Environmental Minor Project Refinement Form

Project Name: West of Devers Upgrade Project Request Prepared By: Sylvia Granados

Date Approval Required: January 4, 2021 Variance Request No.: 43

FIGURE 1
Page 4 of 9

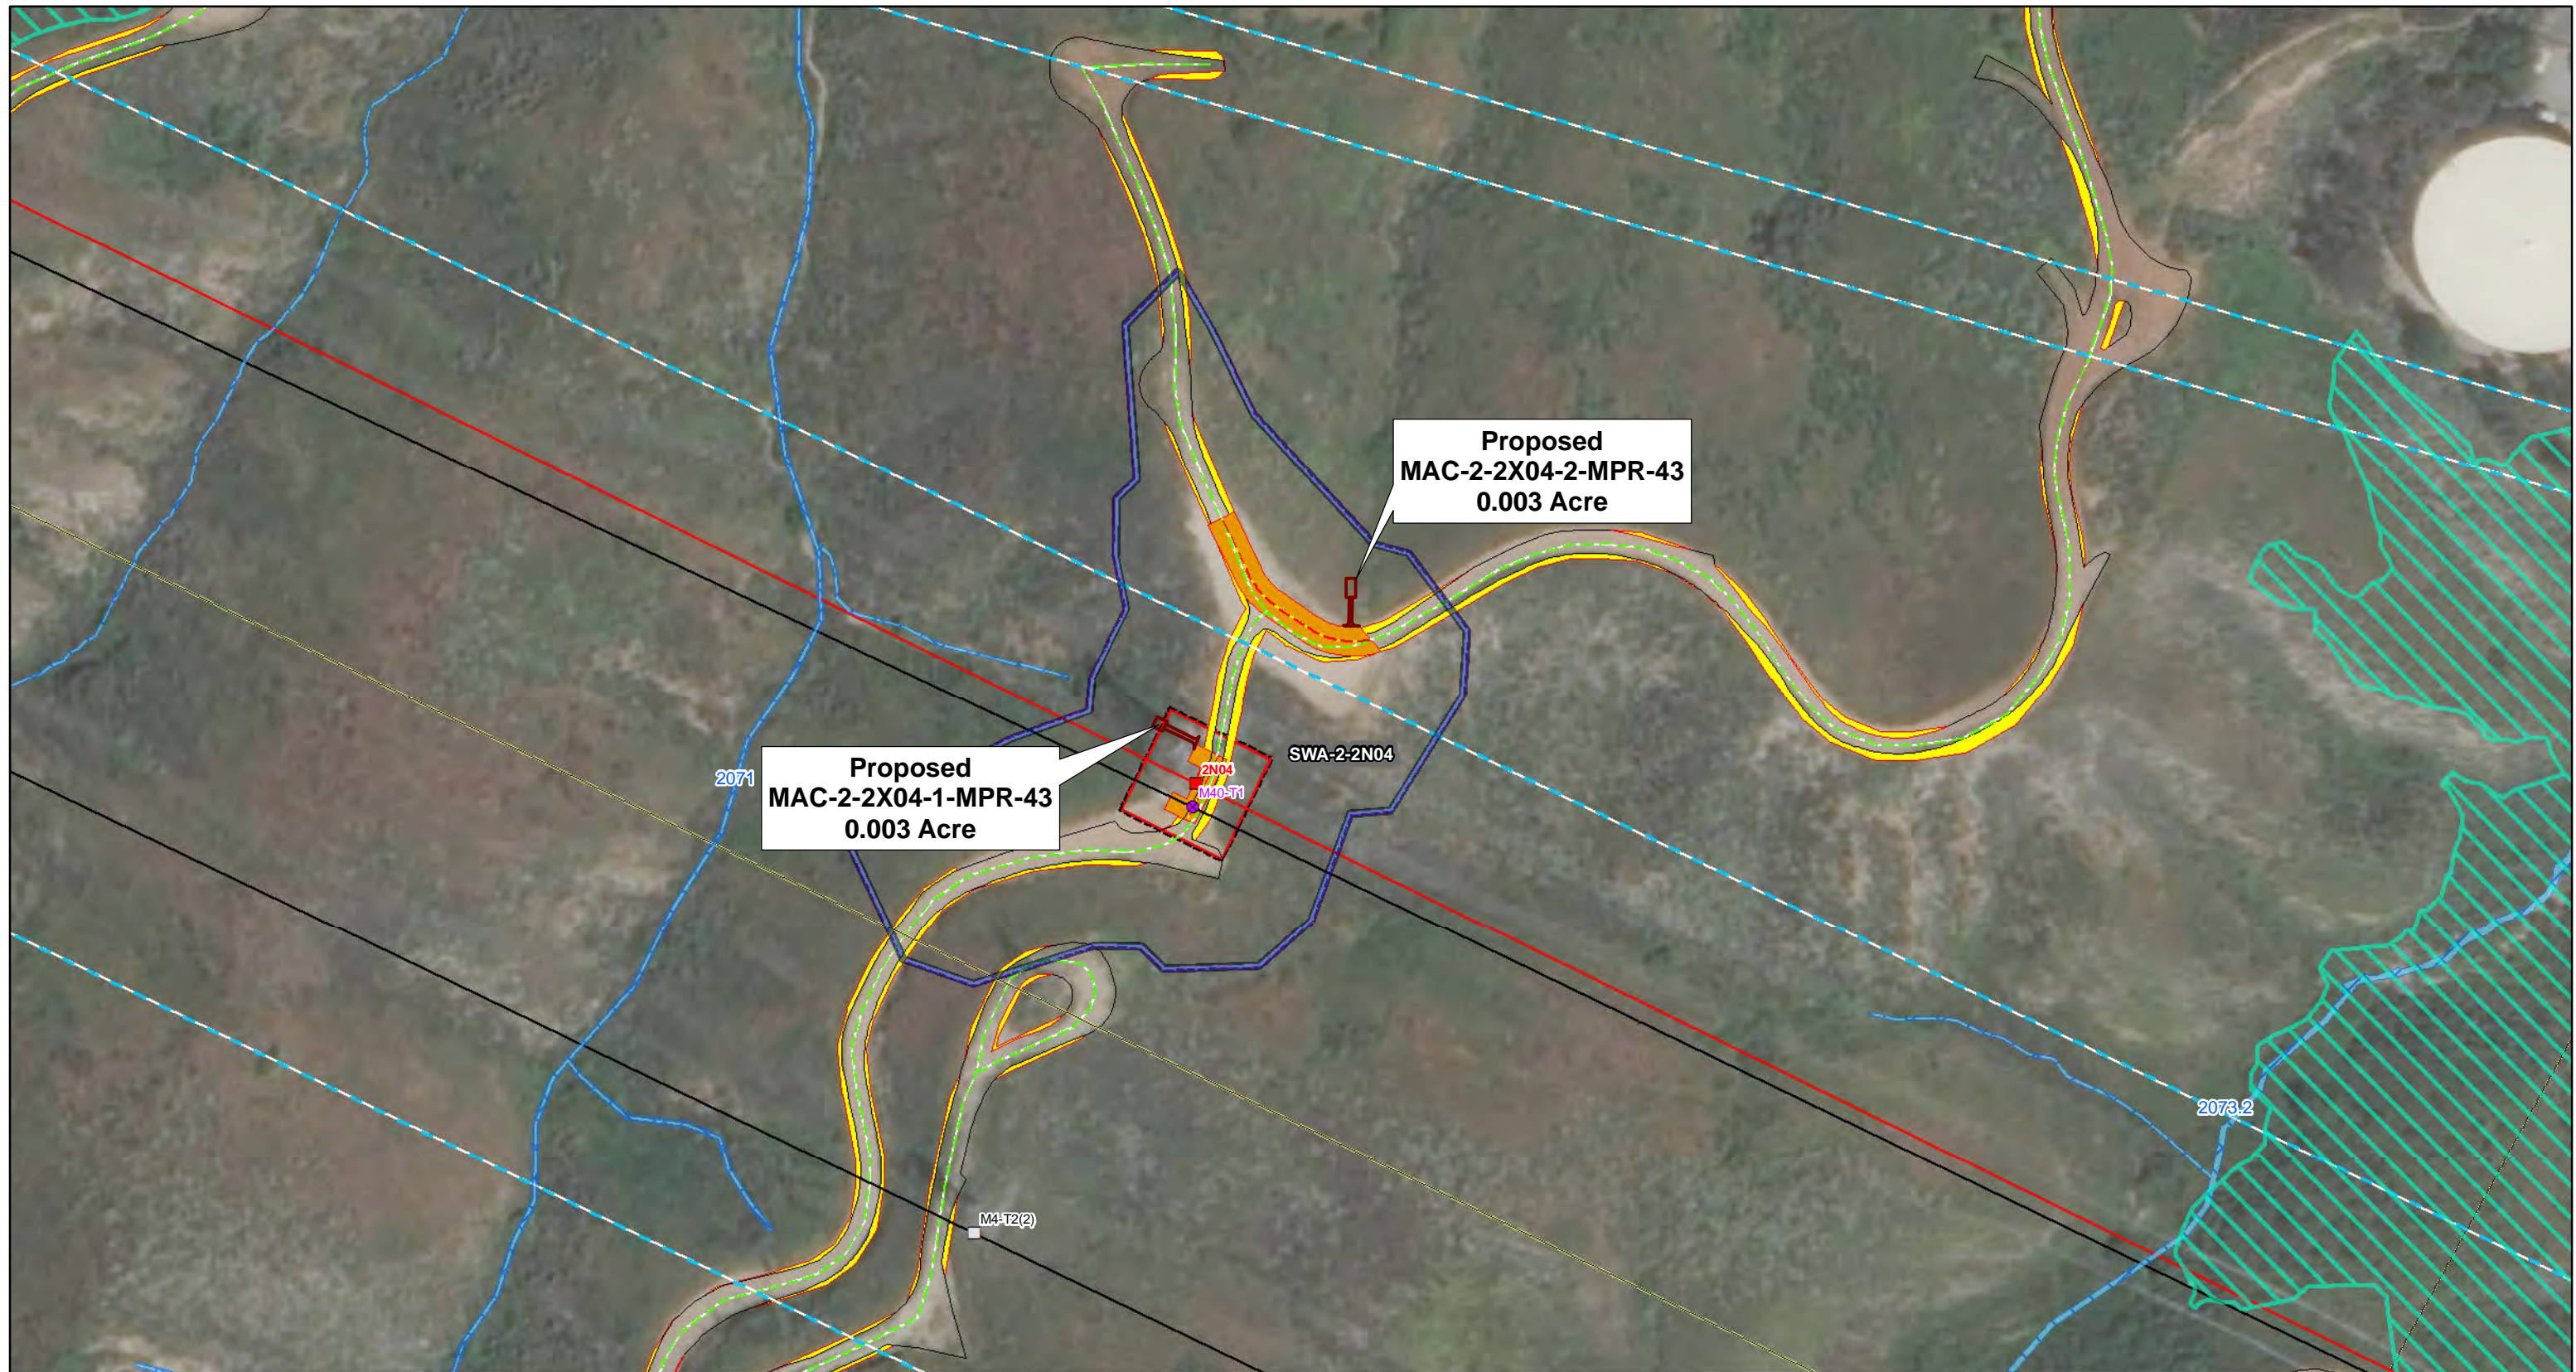
Two new McCarthy Drains are required in Supersite 2X04 to capture and divert surface flows from the 2N04 tower pad to the west and from the access road to the immediate north. MAC-2-2X04-1-MPR-43 will be installed approximately 30 feet north of 2N04 and will run from the tower pad in a northwesterly direction.

MAC-2-2X04-2-MPR-43 will be installed on the north side of the access road approximately 150 feet northeast of 2N04 and will run in a northerly direction to an area of lower elevation. The two new McCarthy Drain will discharge to uplands as shown in Figure 1, Page 4.

Both work areas are located entirely within existing Supersite 2X04 and will not result in an increase in temporary impacts. The features will result in a net increase in permanent impacts of approximately 0.006 acre of public property in the previously approved work area owned by the City of Loma Linda consisting of grassland forbland.

FIGURE 1
Page 6 of 9

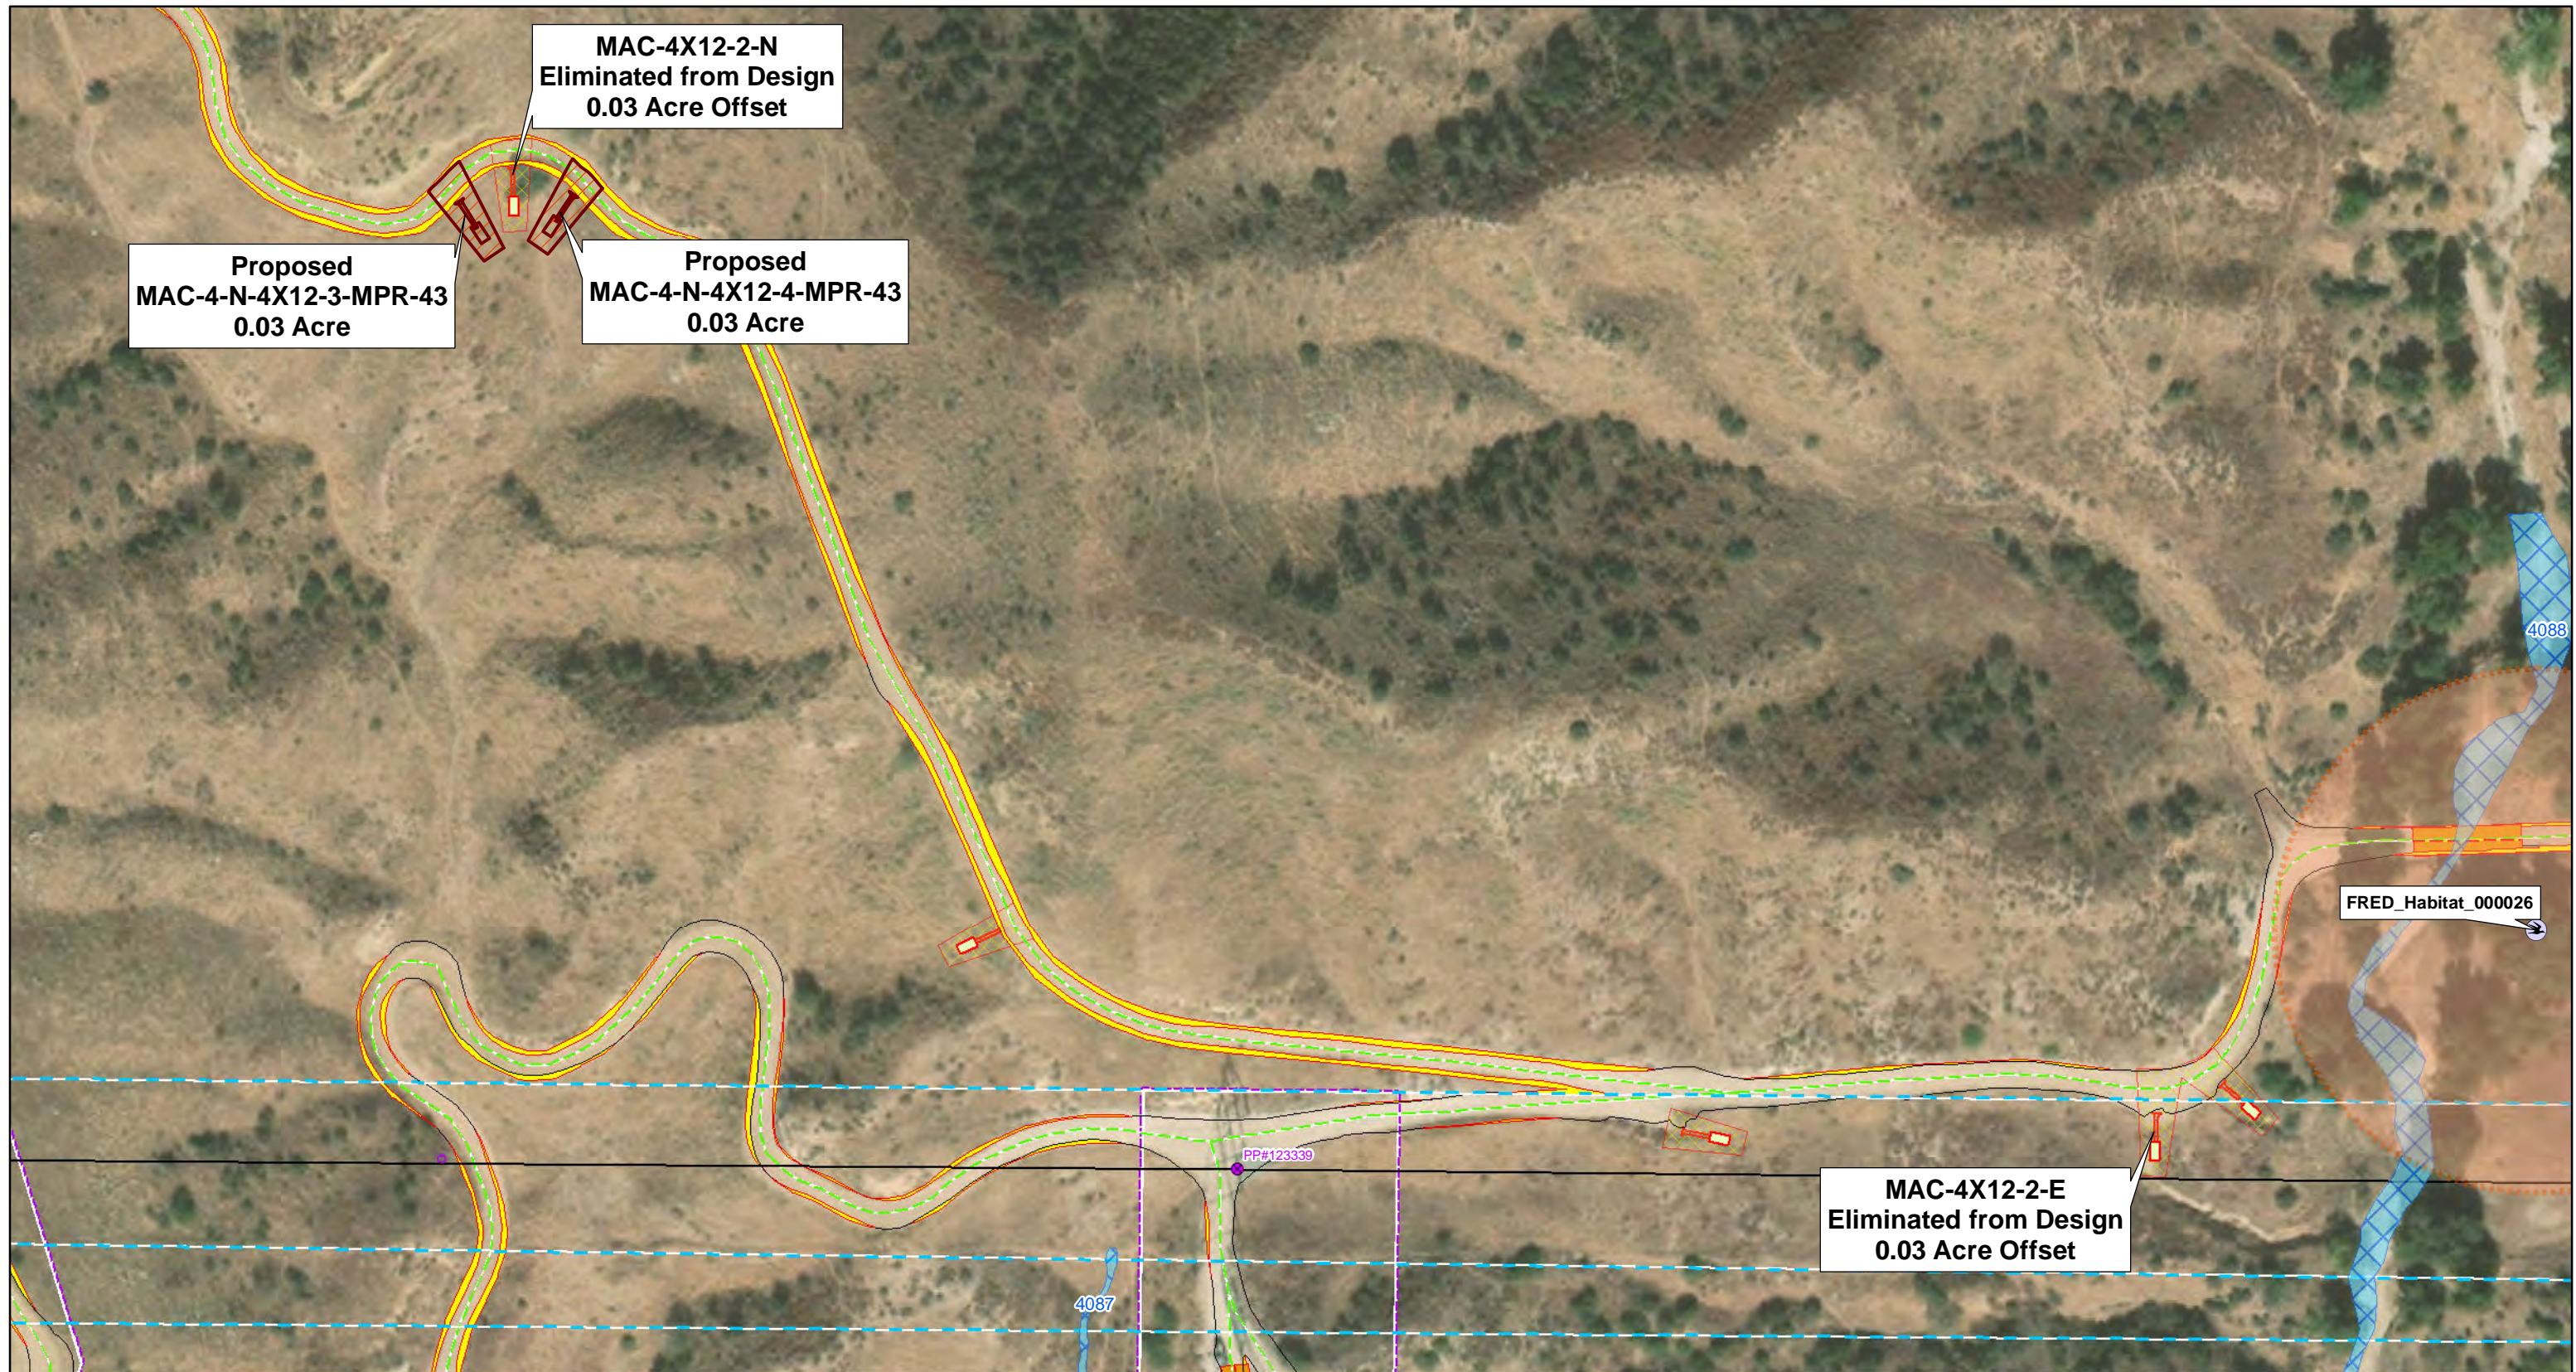
Two planned McCarthy Drains along the utility access roads approximately 1,000 feet northwest of 4N12 (MAC-4X12-2-N) and 620 feet northeast of 4N12 (MAC-4X12-2-E) will be eliminated from the final design and replaced with the two proposed McCarthy Drains shown adjacent to MAC-4X12-2-N, positioned to better capture and divert flows off the access road to adjacent uplands. The proposed utility access road maintenance improvements are shown in Figure 1, Page 6.

The relocated drains are located along the existing SCE utility access road. As redesigned, the proposed features are of equal vegetation impact to the originally designed locations, and therefore offset each other, resulting in no additional temporary or permanent project impacts.

FIGURE 1
Page 7 of 9

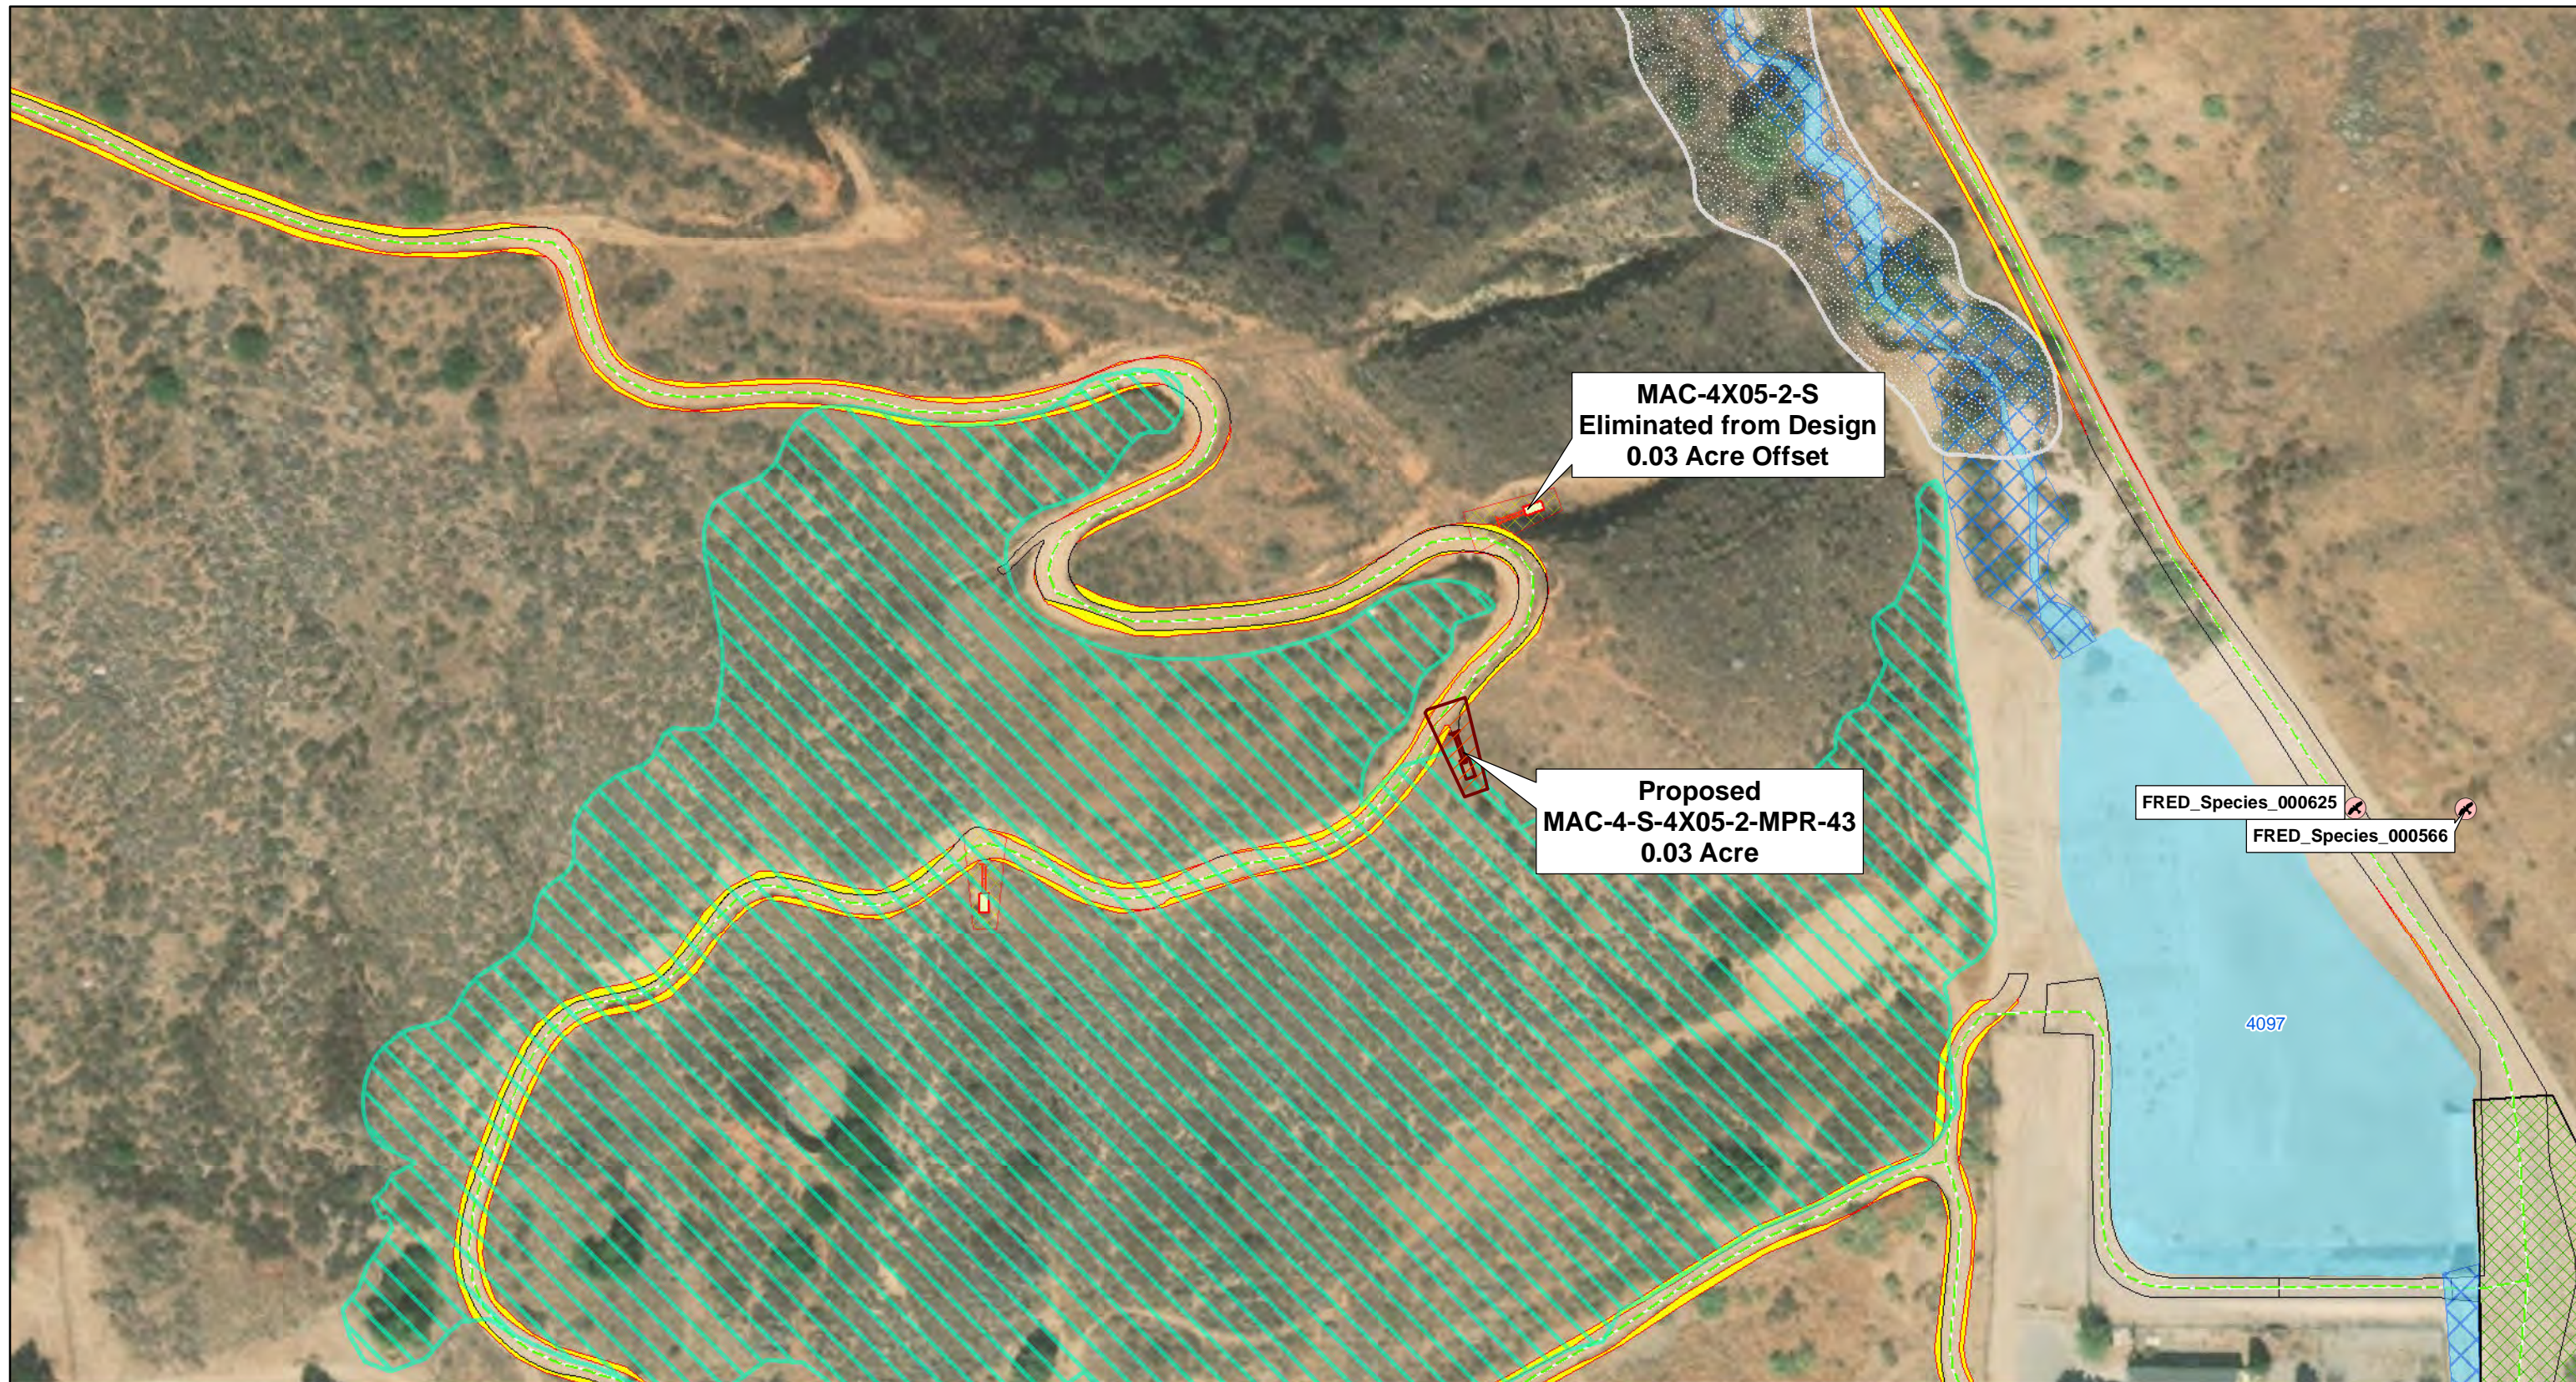
McCarthy Drain MAC-4X05-2-S will be eliminated from the final project design and relocated with McCarthy Drain MAC-4-S-4X05-2-MPR-43, located approximately 140 feet to the southwest, along the southeastern edge of the existing access road, to better capture and divert surface flows from the access road, as shown in Figure 1, Page 7.

The relocated drain is located along the existing SCE utility access road. As redesigned, the proposed feature is of equal vegetation impact to the originally designed location, and therefore offset by the original drain, resulting in no additional temporary or permanent project impacts.
